MJ 11-A

# MJ11-A

**MJ11  
MEMORY TIMING AND CONTROL  
FCO Cross Reference**

**Engineering Change Order Log**

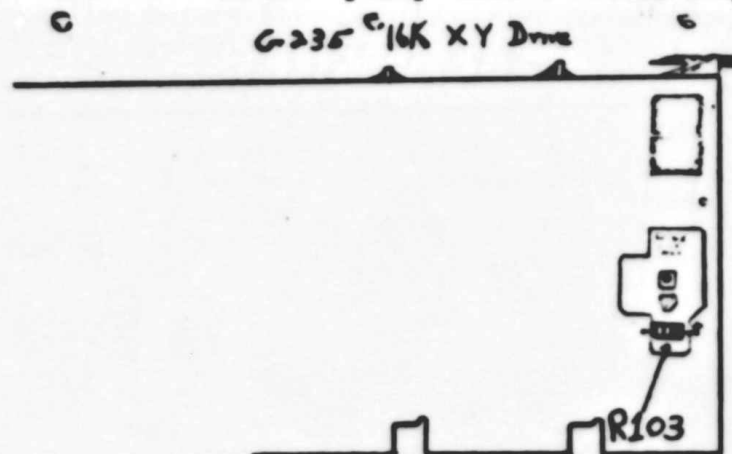
Many reports have been received from the field concerning memories failing high current margins and module set incompatibility (i.e. unable to swap modules). Investigation has shown that the inhibit margins are not properly centered, which could cause marginal operation of the memory under conditions of high drive currents. An ECO (G235-0009) was generated to correct this problem.

Therefore, if a memory exhibits these symptoms, do a visual inspection of the G235 for the ECO. A quick check for the ECO is:

1. Place G235 component side up and fingers toward you.
2. Look at right hand side of module in large etch area (see drawing).
3. If resistor R103 (75Ω 1W) which is across bottom of large etch is not in, ECO has not been installed.

This ECO should be installed before attempting massive module swap or option swap.

ELO # MM11E-00016

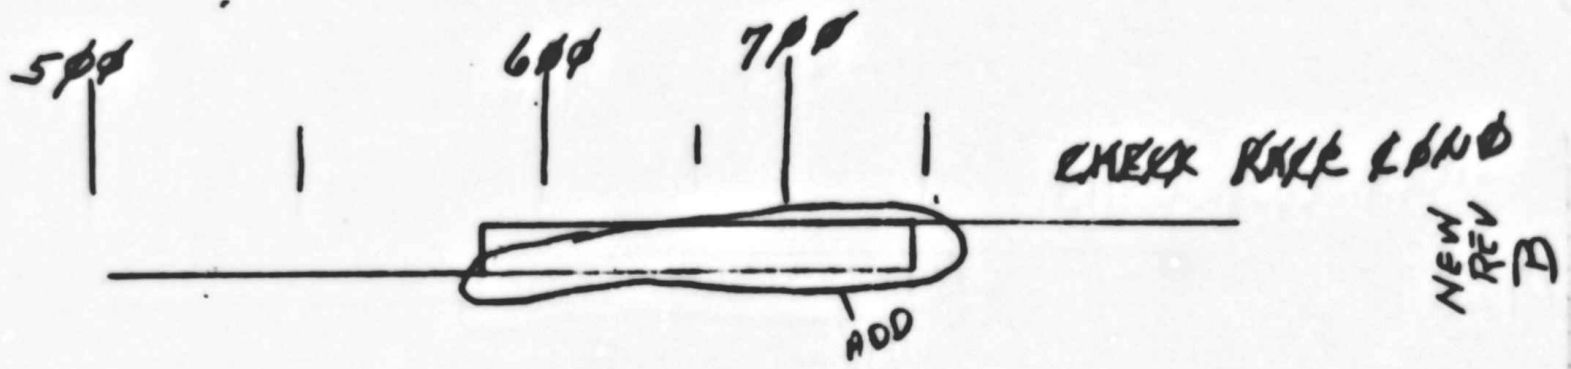
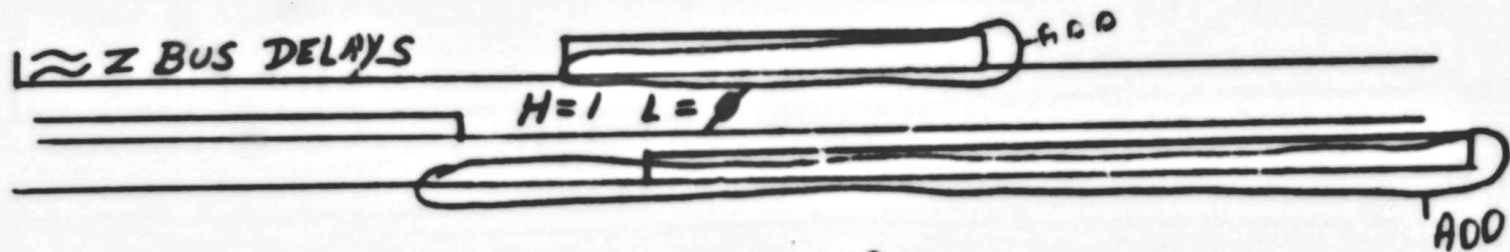
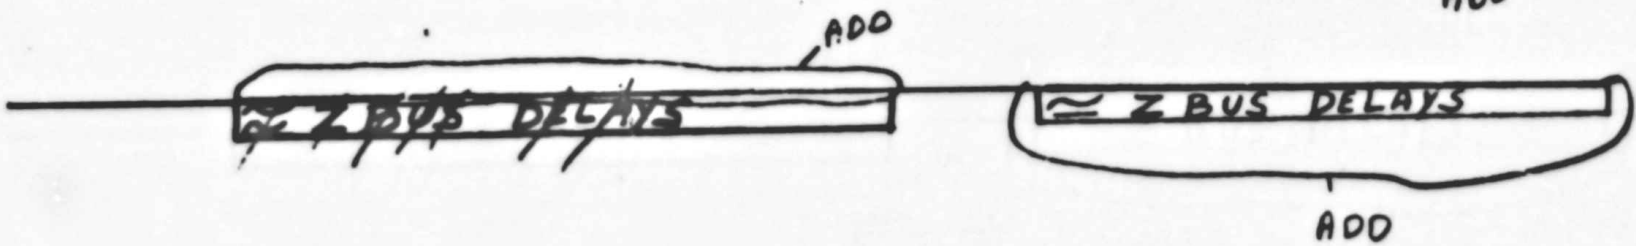
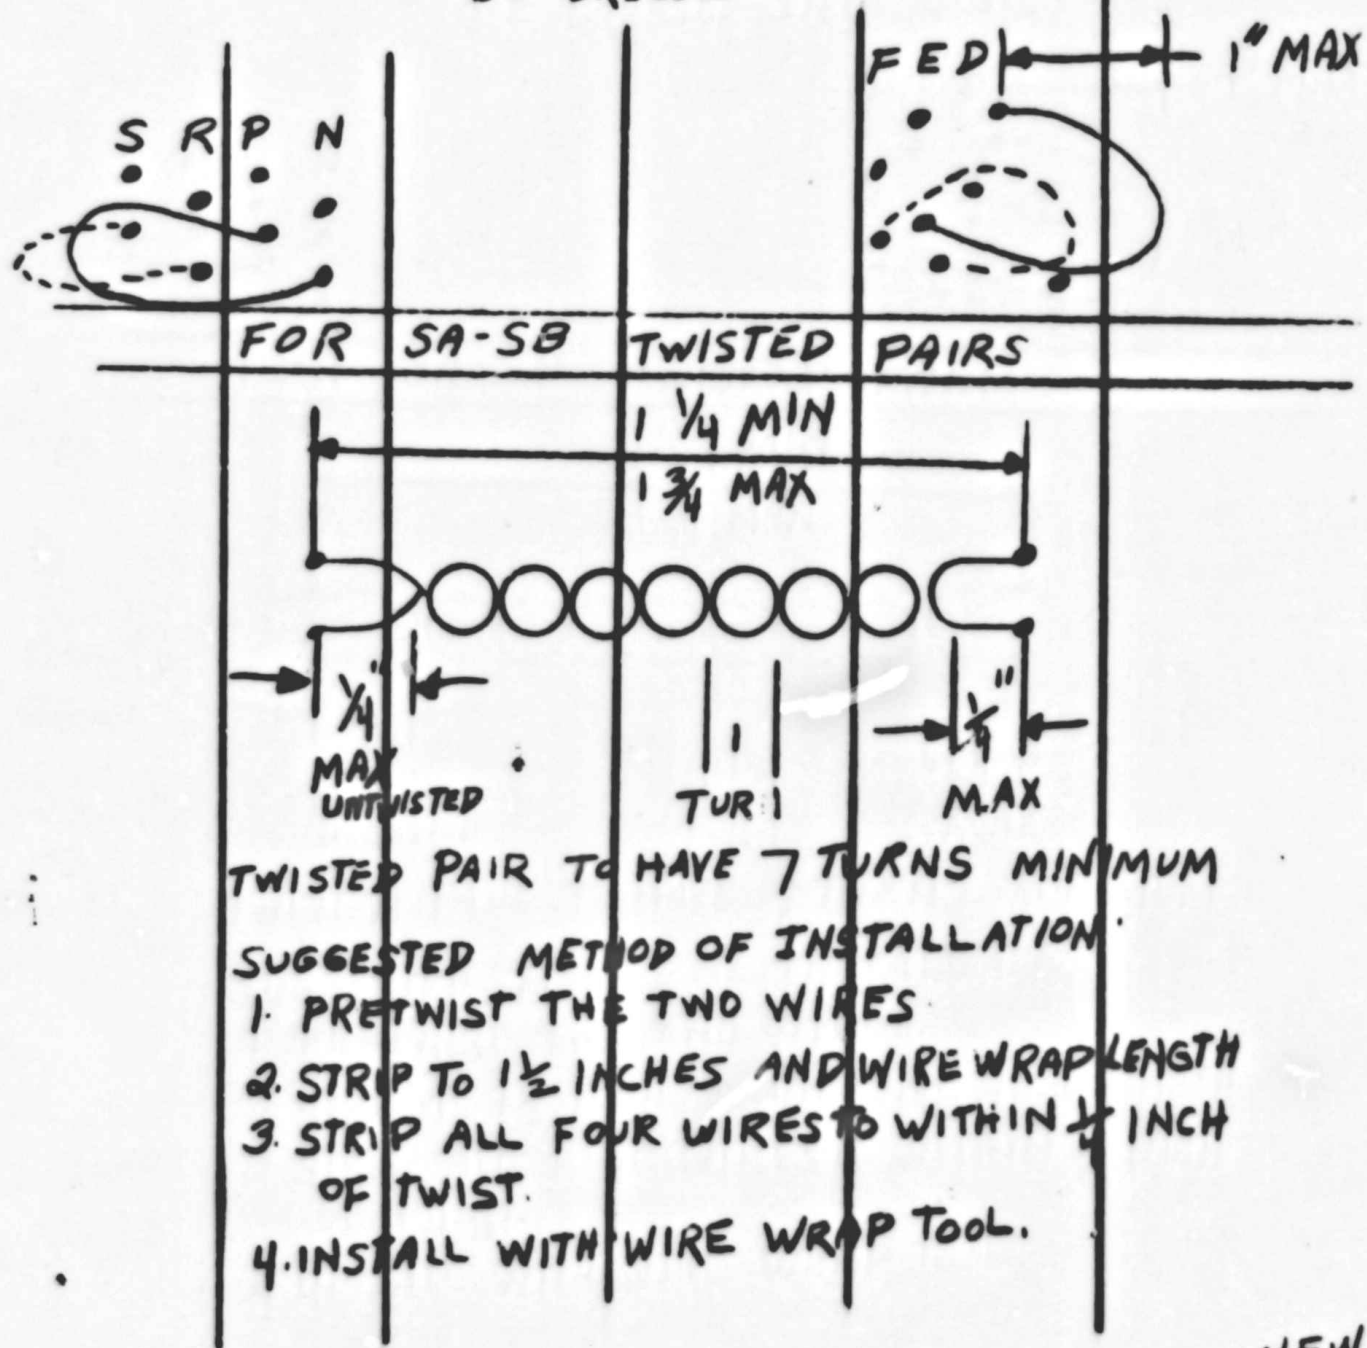
- TIMING + FLOW DIAGRAM WRONG.
- NOT ENOUGH INFORMATION GIVEN ON THE DRAWING TO INSURE THE REQUIRED RESULTS WHEN HAND WIRE. WRAPPING. TWISTED PAIRS WILL PICK BACK PLANE NOISE UNLESS DONE CORRECTLY.

LENGTH SHOULD BE A MAXIMUM OF  
 $2\frac{1}{4}$  INCHES. CHECK DRAWINGS FOR  
 LENGTH AND FOR HOW LOOPS SHOULD  
 BE DRESSED INTO LOGIC.

- CORRECT TIMING + FLOW DIAGRAM
- ADDITIONAL INFORMATION PUT ON THE PRINT.

ECO NO.  
MM11E-00017  
Sheet 3 of 4

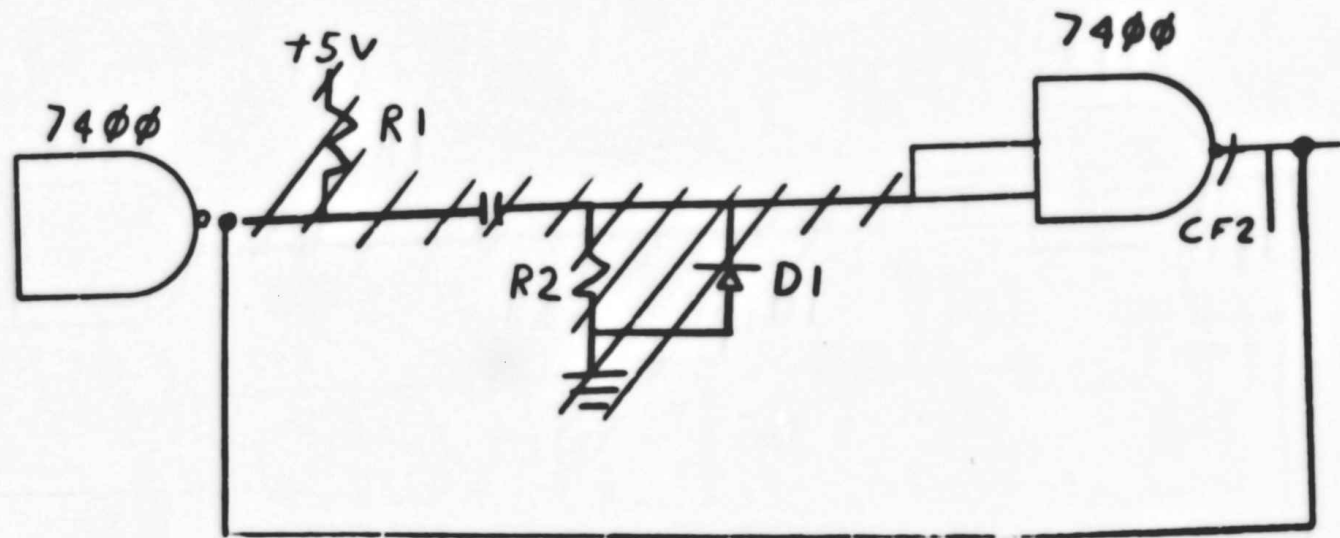
| 1. CHANGED TEST PROCEDURE TO IMPROVE MEMORY PERFORMANCE.<br>2. CORRECT WIRE LIST ACCORDING TO SUBMITTED ADD/DELETE SHEET.<br>3. UPDATE BLOCK SCHEMATIC PER ATTACHED MARKED UP PRINT.<br>4. UPDATE TIMING AND FLOW DIAGRAM AS INDICATED .<br>5. REMOVE WRITING FROM MARGIN.   |   |  |

| ITEM | DOCUMENT/OR PART NUMBER | OLD REV | NEW REV | (PART NAME) DESCRIPTION OF CHANGE  | DISP CODE |
|------|-------------------------|---------|---------|--|-----------|
| 4    | D-TD-MM11-E-08          | B       | C       | (TIMING DIAGRAM)<br>DELETE CHECK RACE COND. IN MARGIN.<br>INCREASE TIME AND FLOW IN DISZ BEFORE 650NS. INCREASE TIME AND FLOW IN CINZ BEFORE 350 NS.   | 06        |
| 5    | A-SP-MM11-E-11          | -       | A       | (ENGINEERING SPECIFICATION)<br>DELETE FROM PARA. 11.0 210 NS .<br>ADD 220NS. ADD TO PARA. 13.4- IF THE MARGIN IS GREATER THAN 1.0V SET VXY AT 0.5 BELOW THE FAILING HIGH END POINT. (EXAMPLE IF MARGINS ARE 0.4 TO 1.8V, SET AT 1.3V= 1.8-0.5) | 06        |

| digital | CORE MEMORY STACK (Y DRIVE) |                         | NO. D-BS-MM116-03 | REV B |

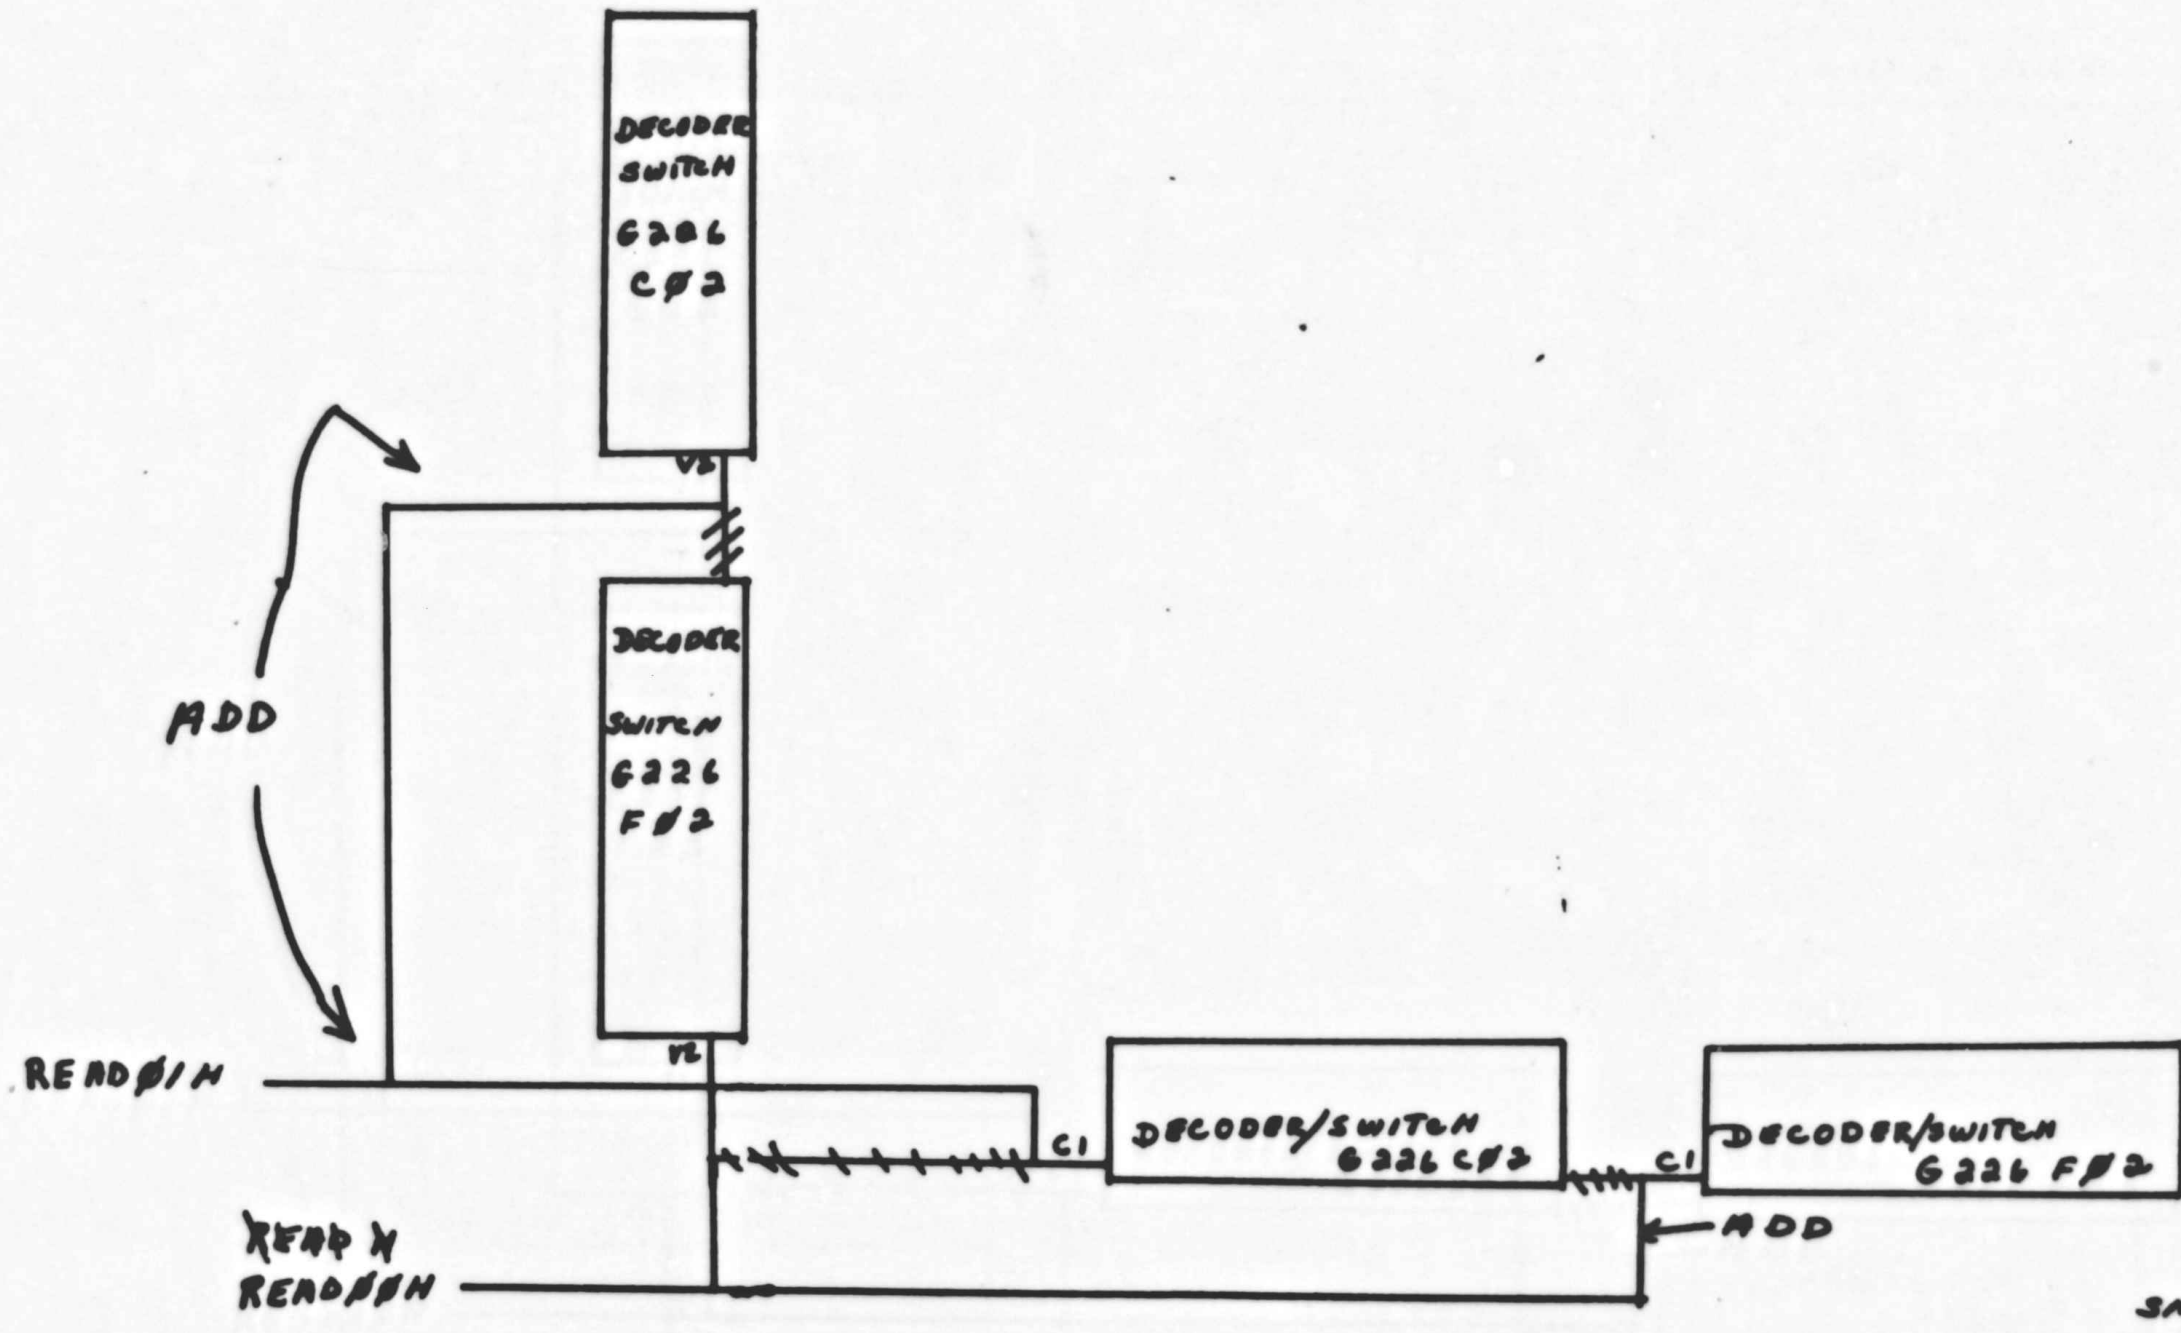
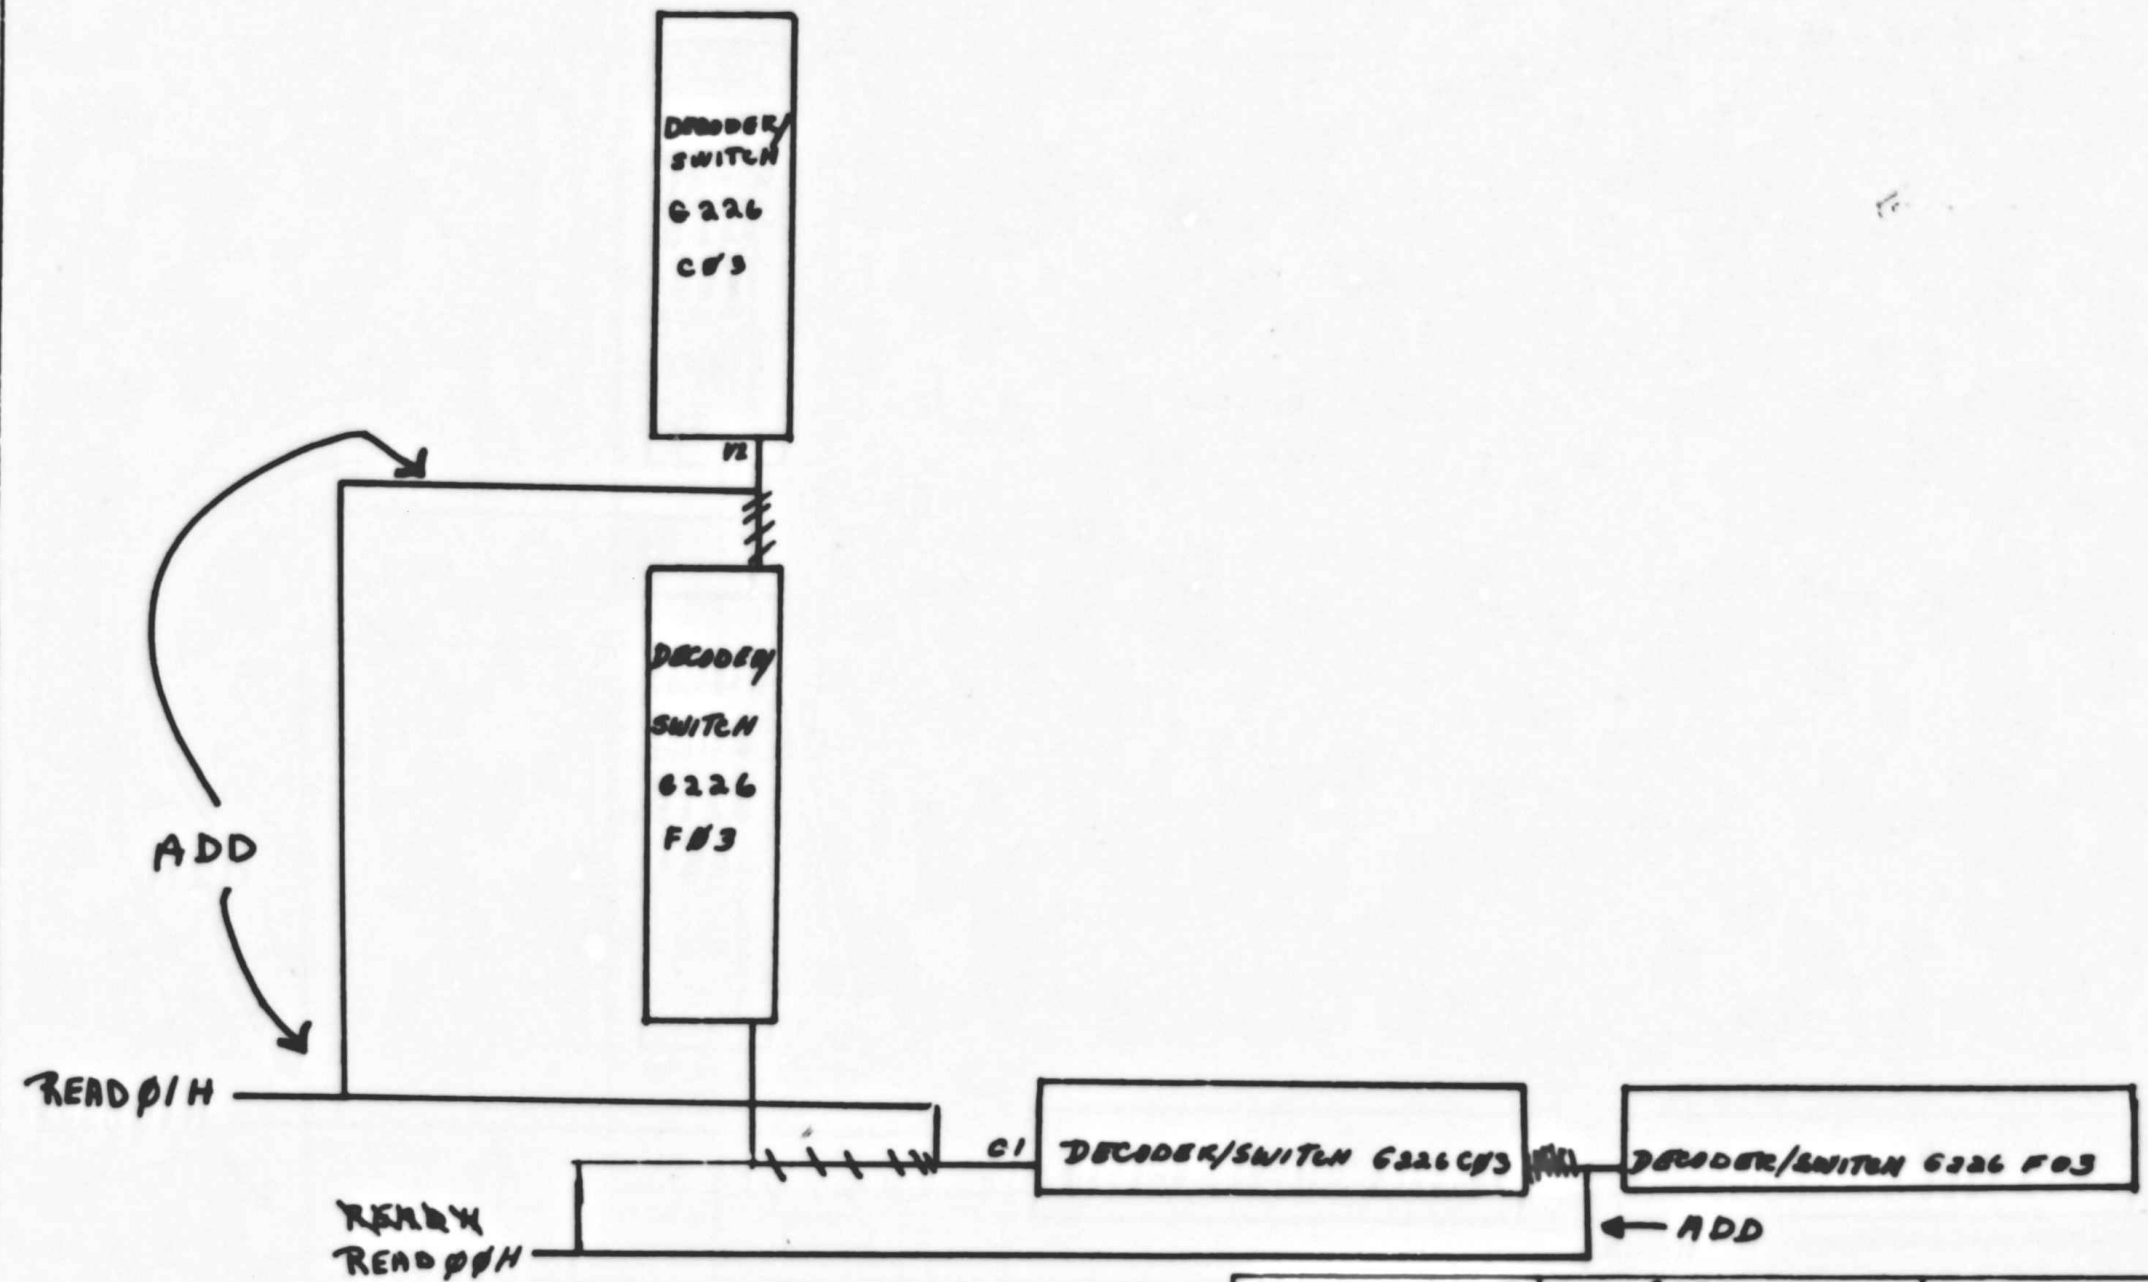
| ITEM NO. | DOCUMENT/PART NO. | OLD REV | NEW REV | DISP CODE | DESCRIPTION OF CHANGE                                    | DOCUMENTATION AFFECTED               | FIELD SERVICE AFFECTED  | TYPE OF CHANGE                                 |
|----------|-------------------|---------|---------|-----------|--|--------------------------------------|---|--|
| 3        | D-BS-MM11-E-03    | A       | B       | 06        | Core Memory stack (2 sheets)<br>See final release print. | <input type="checkbox"/> TECH MANUAL | <input checked="" type="checkbox"/> Product Line Change             | <input type="checkbox"/> MODULE                |

NOTES  
Necessary to improve reliability on existing units.
